Periodic Training Sequence Issues for 40G/2.5/5GBASE-T

IEEE 802.3bq / bz – July 2015

Brett McClellan, Marvell

Spectrum

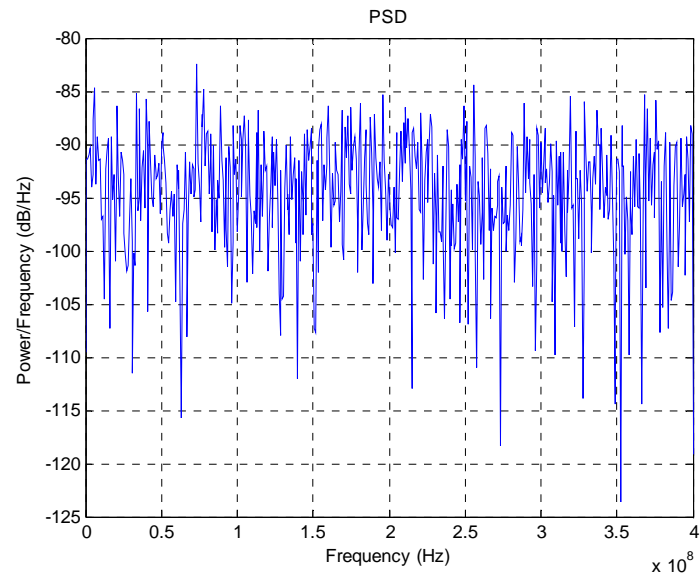
- ▶ Insufficient statistics to train Equalizers and Cancellers during PTS
- ▶ DC imbalance & spectral nulls
- ▶ Problem for decimated/shared adaptation loops:
 - e.g. DC offset of >10%
 - Nulls > 35dB
